CITY OF ST. LOUIS
**PLANNING & URBAN
DESIGN AGENCY**
CULTURAL RESOURCES OFFICE
FRANCIS G. SLAY, Mayor

DATE: May 23, 2016
ADDRESSES: 1024 Mississippi Avenue
ITEM: Preliminary Review: Exterior alterations to a 2-story house
JURISDICTION: Lafayette Square Local Historic District — Ward 6
STAFF: Jan Cameron, Cultural Resources Office

1024 MISSISSIPPI AT LASALLE

REVISED PLAN SHOWING CANOPY ROOF IN GREEN, KITCHEN IN RED

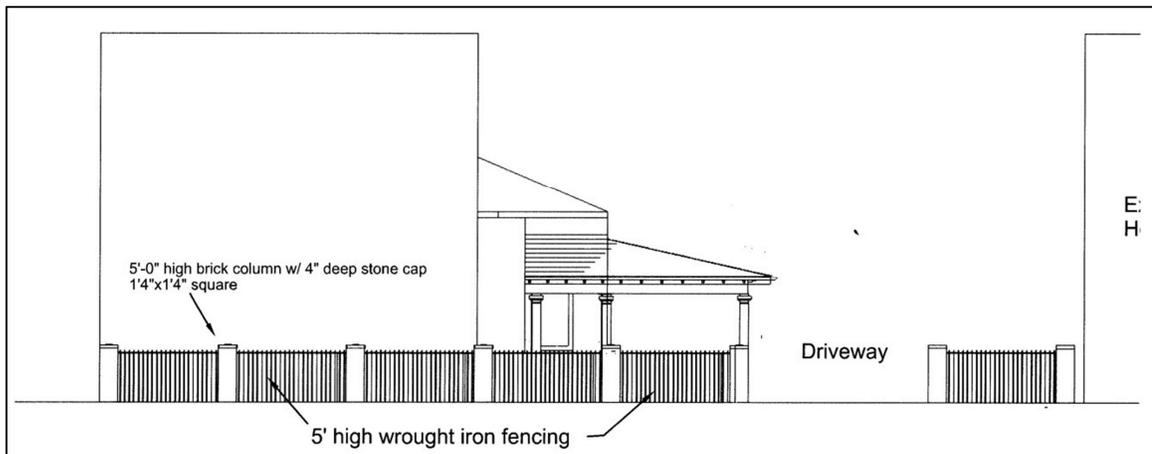
The applicant proposes a permanent barbecue structure, to be located at the northern property line, and a large patio cover, constructed of wood with a metal roof, that will extend approximately 20 feet from the rear wall of the house and 20 feet to the west, wrapping partly around an existing 1-story rear addition.

Does not comply. The revised roof structure has changed little from the first submission except that it proposes a standing seam metal roof in place of the glass roof originally

presented. It also does not comply with the requirements of a Historic Model Example, in that it is attached to a projecting bay rather than the side elevation of its HME.

Based on the Preliminary findings, the Cultural Resources Office recommends that the Preservation Board grant preliminary approval to the fence and barbecue, subject to final review of the fence design and materials by the Cultural Resources Office staff; but that the Board withhold approval of the proposed patio cover unless its scale and design are revised to follow a Historic Model Example.

EAST VIEW OF CANOPY

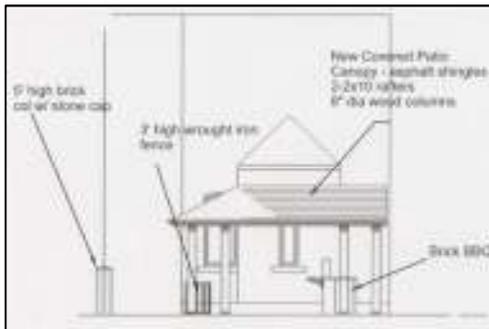
The patio cover has been slightly redesigned, broadly based upon a porch on Benton Place. That porch, however, is attached to the side wall of the house; attaching a similarly-scaled porch to the small projecting one-story bay on the rear of 1024 Mississippi does not follow the Standards' requirements for an appropriate Historic Model Example (HME).

BRICK OUTDOOR KITCHEN

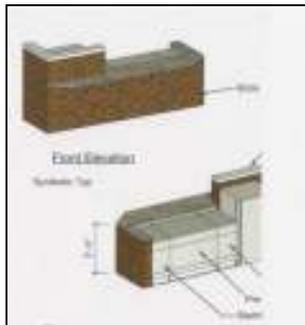
Does not comply, as the barbecue, a modern convenience is placed in the rear yard of 1024 Mississippi which is considered a public yard. However, as it has been relocated to the north side of the property and screened by a brick wall, it will have minimal visibility and therefore is acceptable.

INSTALLED WALL

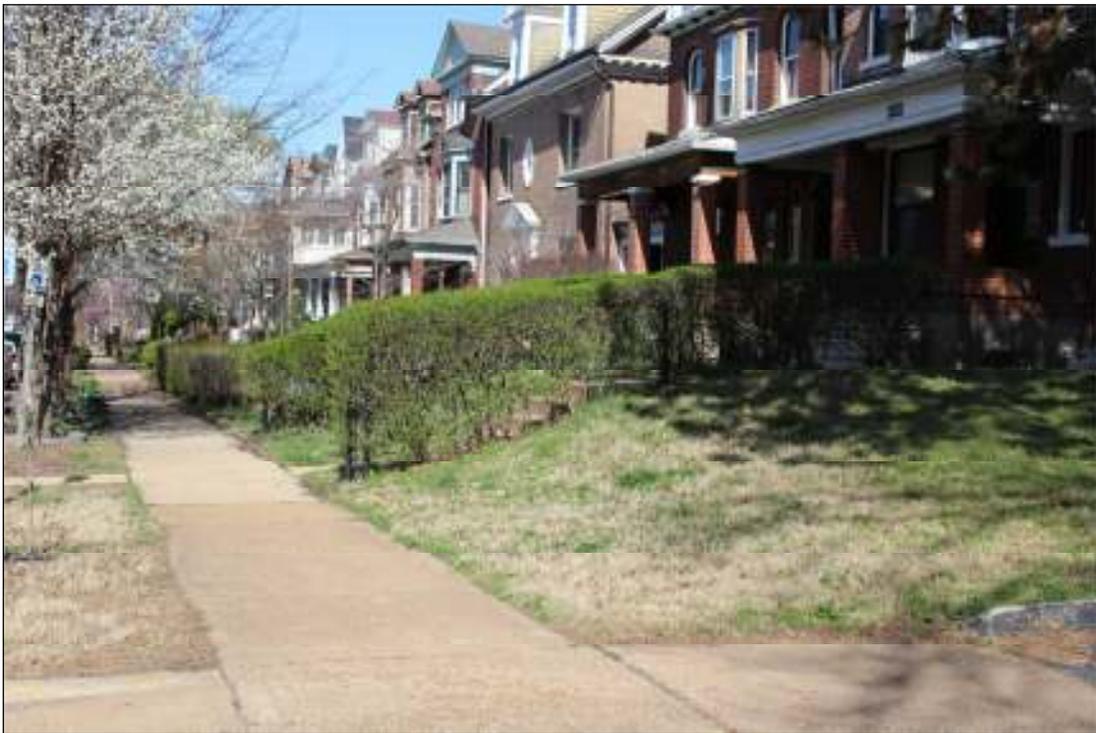
Does not comply. The original terrace has been altered and a new concrete block retaining wall has been installed. Both the new retaining walls and the material are prohibited under the standards.

Based on these preliminary findings, the Cultural Resources Office recommends that the Preservation Board uphold the Director's denial of the application as it does not comply with the Central West End Local Historic District standards.

VIEW OF SITE PRIOR TO INSTALLATION OF RETAINING WALLS FROM GOOGLE STREET VIEW MARCH 2015

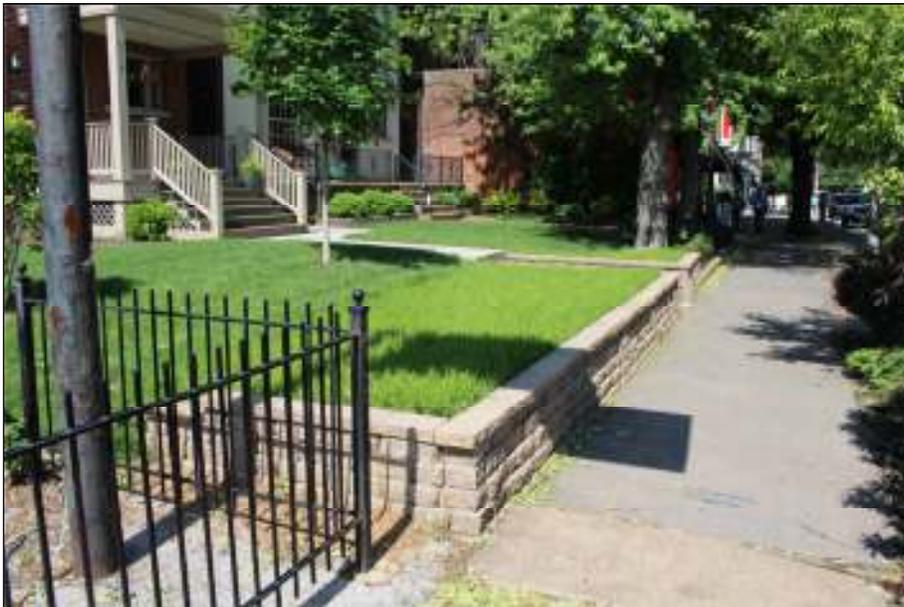
Does not comply. The installed wall is an artificial material that does not replicate any material dominant within the historic district.

Does not comply. The original terrace has been altered by the introduction of a new artificial stone block retaining wall.
